RECEIPT DATE: 4/27/18 **ONSITE SEWAGE DISPOSAL SYSTEM**

PROPERTY ADDRESS: 2018 Terrapin Creek Sykesville, MD 21784

From: Oswald, Hank <hoswald@howardcountymd.gov>
Sent: Thursday, January 18, 2018 9:11 AM
To: Ron Thompson
Subject: OSDS Plan Review Comments_2018 Terrapin Creek
Attachments: Septic spec_Lot 19.pdf

ON SITE SEWAGE DISPOSAL SYSTEM DESIGN PLAN

Drawing: BASEMENT/ FOUNDATION PLAN
Project: CATONSVILLE HOMES
DEVONSHIRE
TERRAPIN CREEK LOT 19

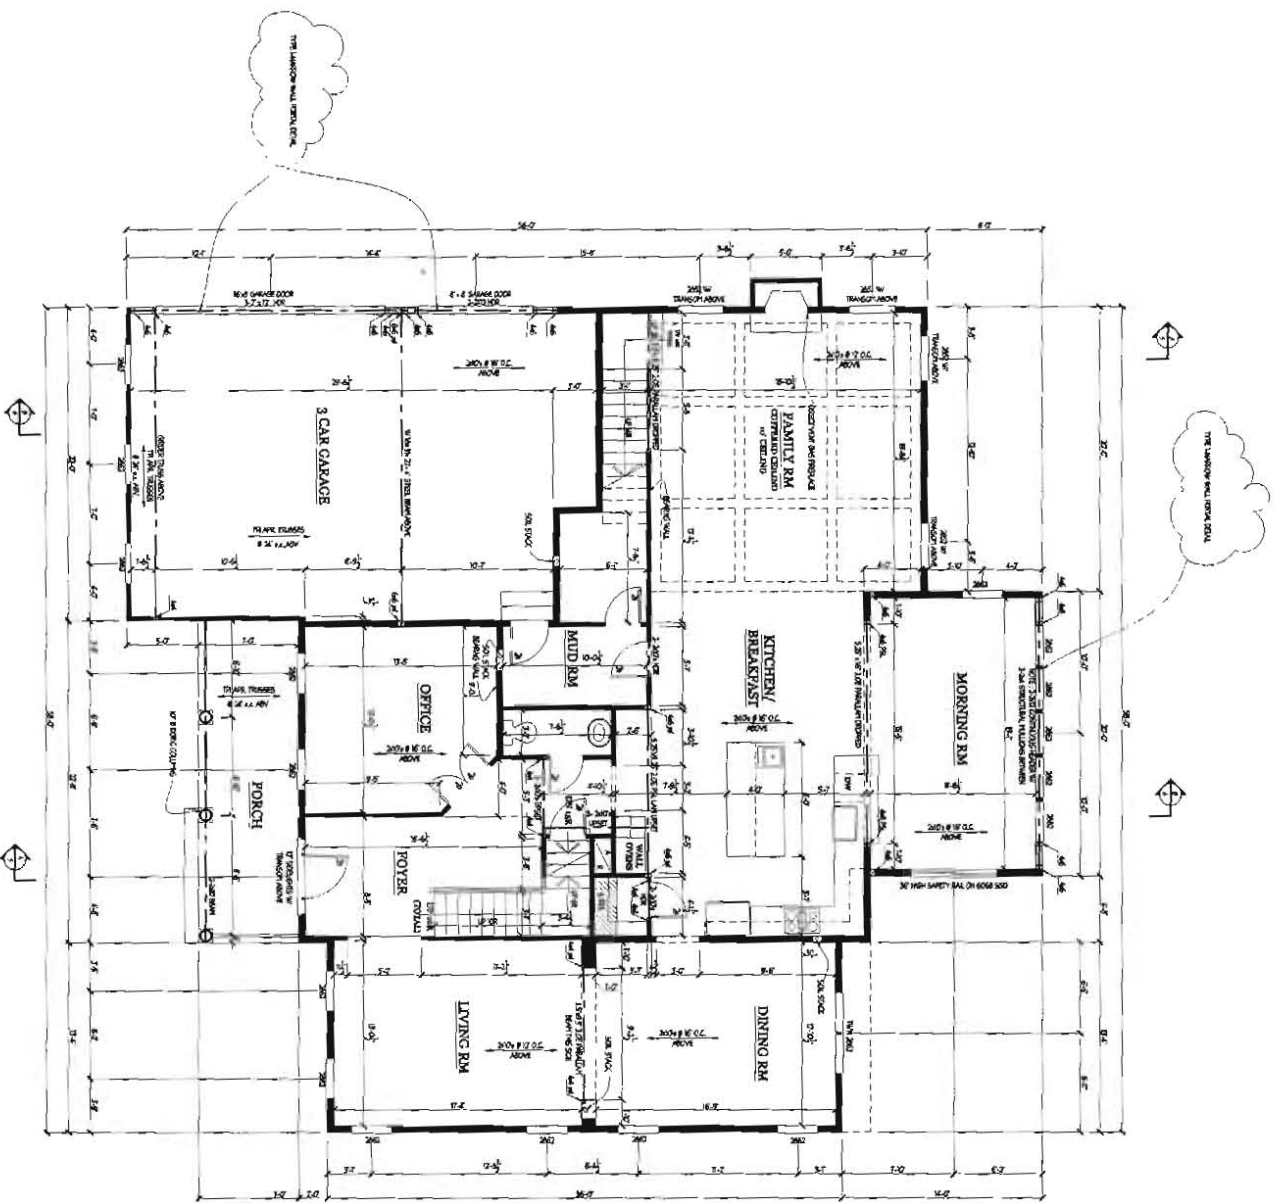
Thank you for the clarification. Currently, I am reviewing the OSDS Plan by the engineer and I will be sending comments soon. We won't count the 2nd floor bonus room as a bedroom since it has a cased opening of at least 4 feet w/o a door but we will count the "office" in the basement as one. This room brings the total # of BR's up to 5.

1BR

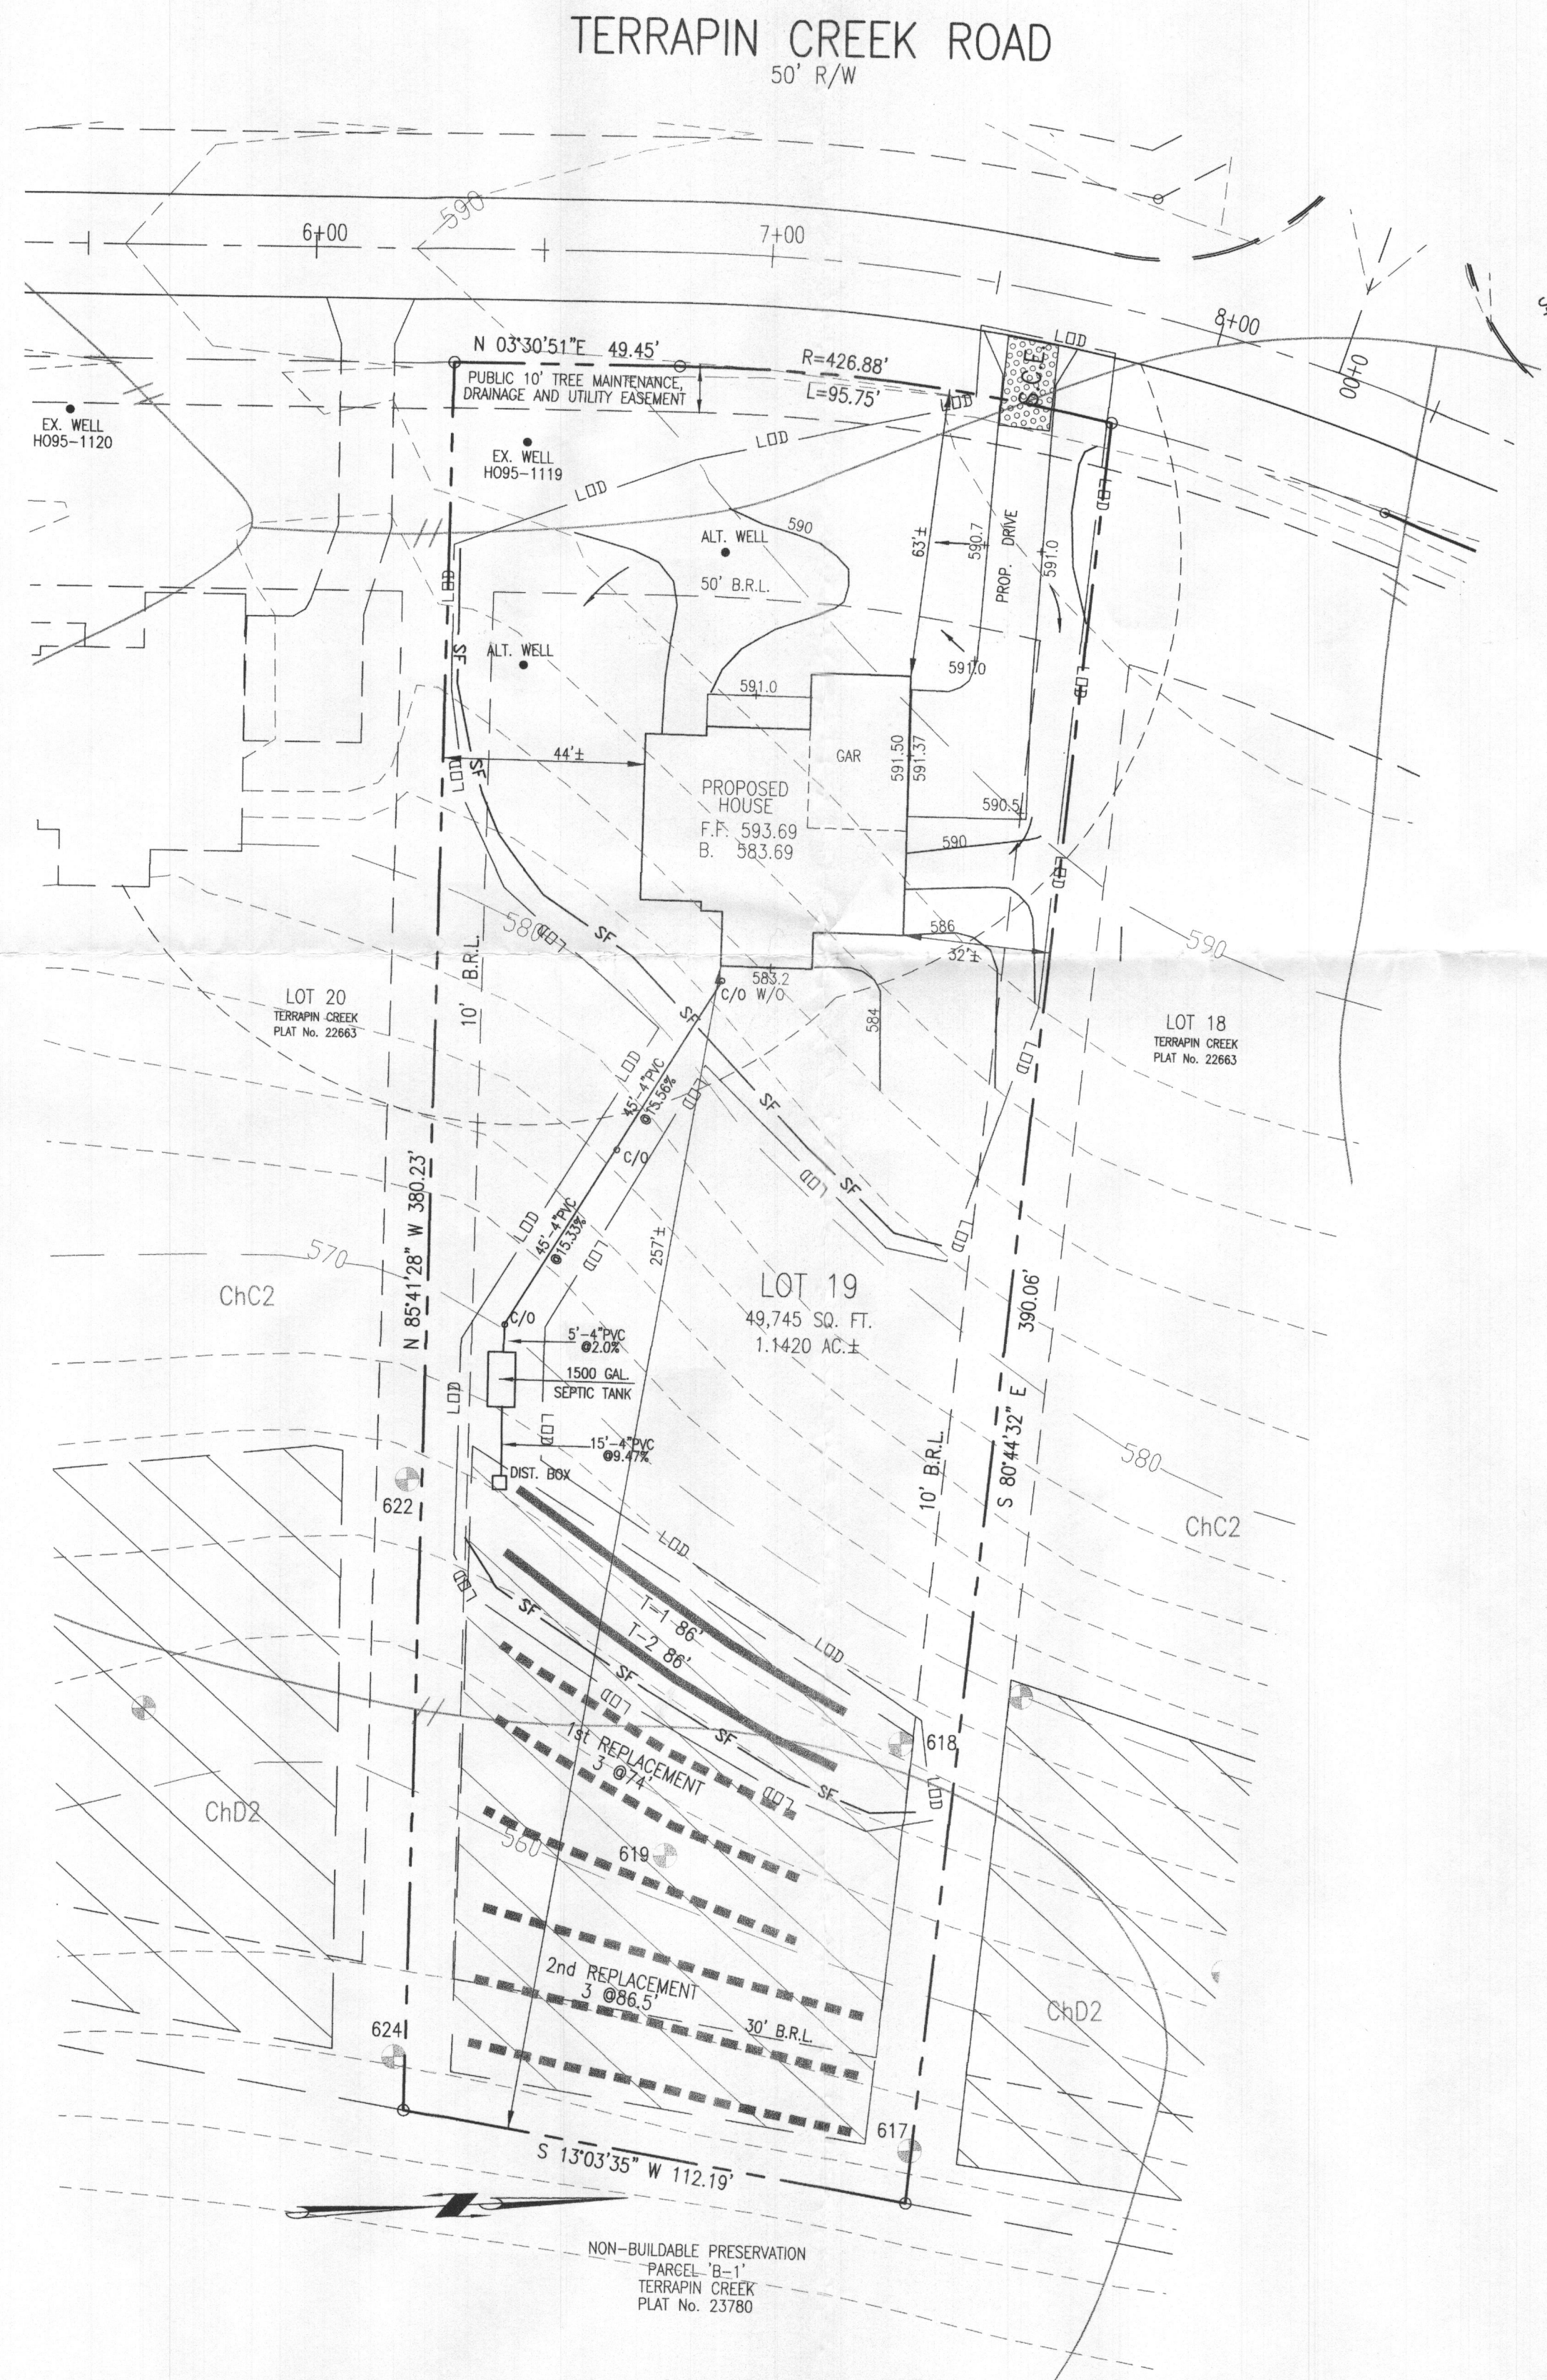
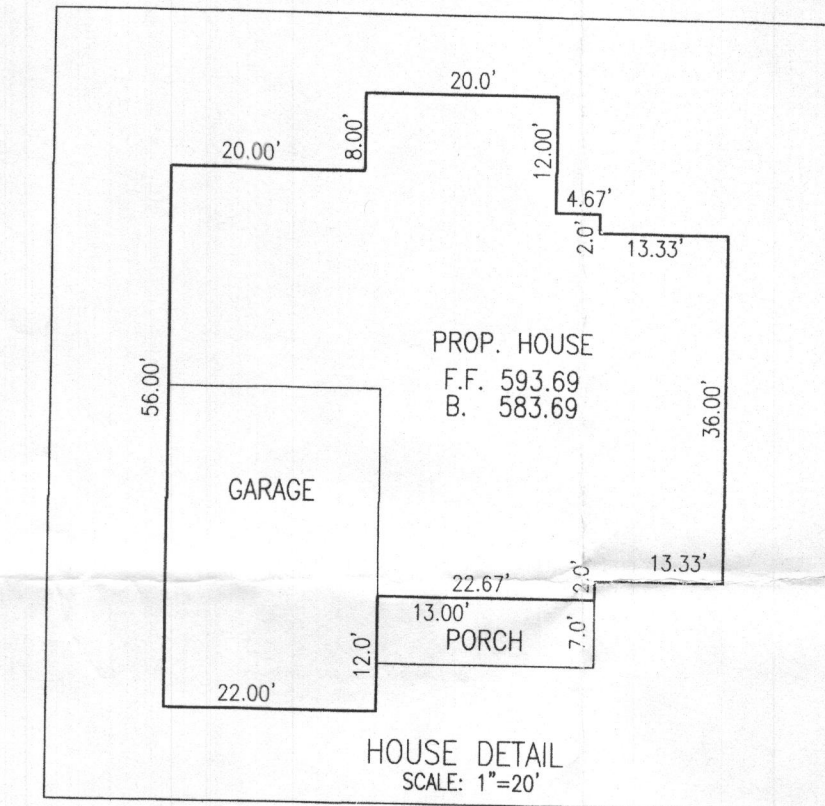
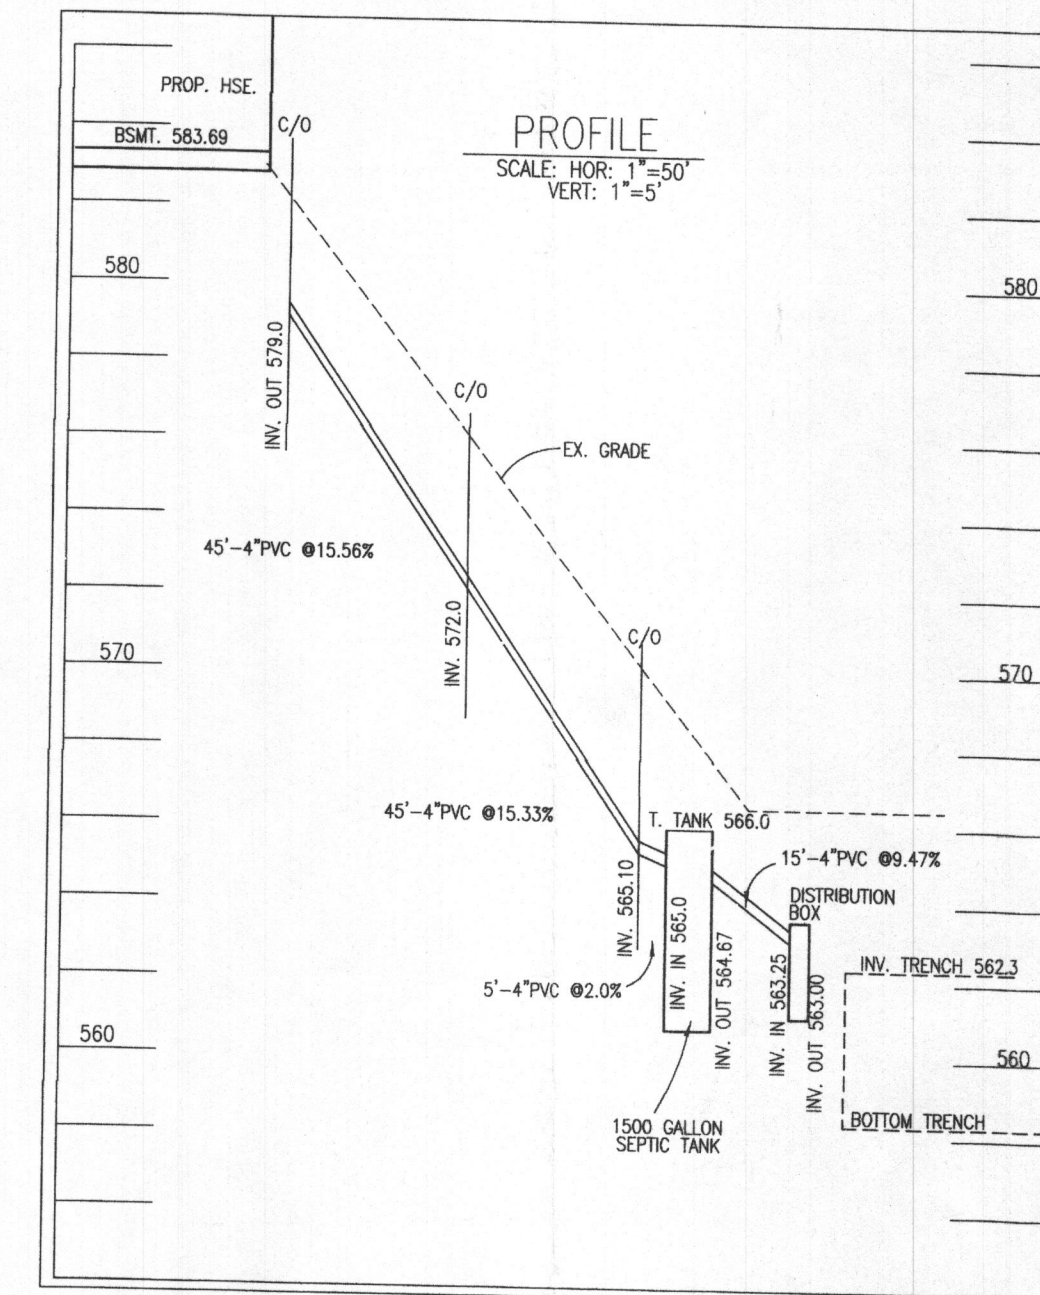
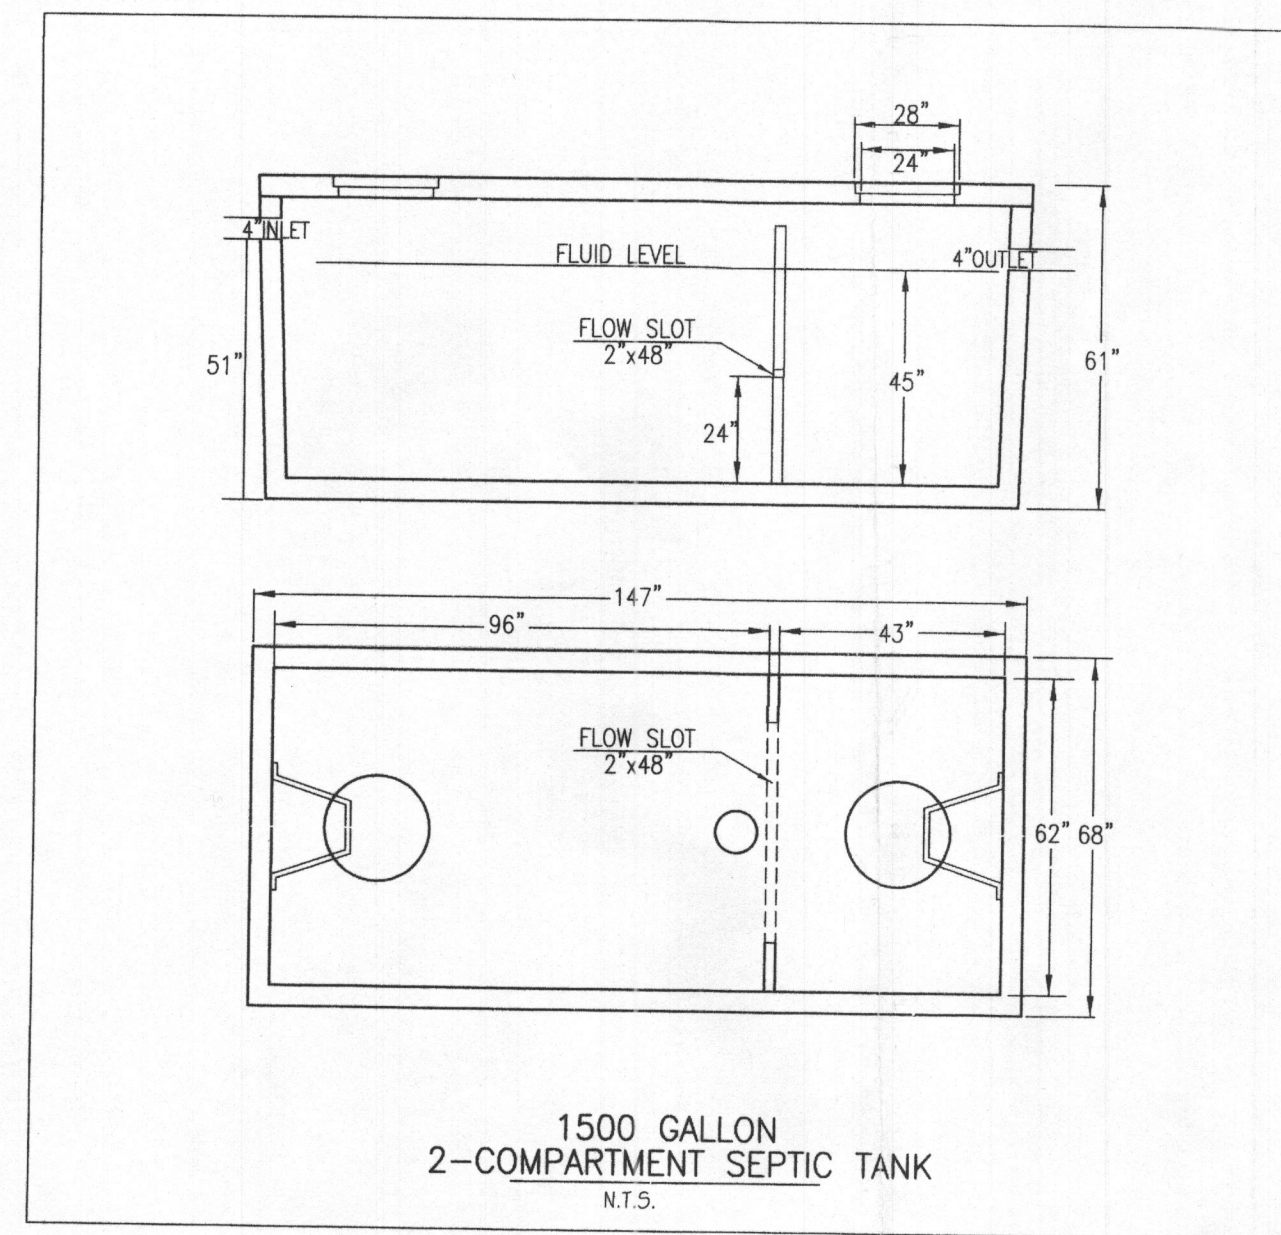
- 1.) Match length of line between last c/o and tank on the septic profile (10 ft.) & layout (5 ft.).
- 2.) The reduction credits (RC) should be as follow; Initial System R.C. is 0.55 (2.5 ft.), First System RC is 0.71 (1.5 ft.) and Second System RC is 0.83 (1 ft.)
- 3.) Floor plans shows 5th bedroom in basement. Redesign septic plan for a total of 5 BRs.

DATE	REVISIONS
01/19/18	PER COMMENTS
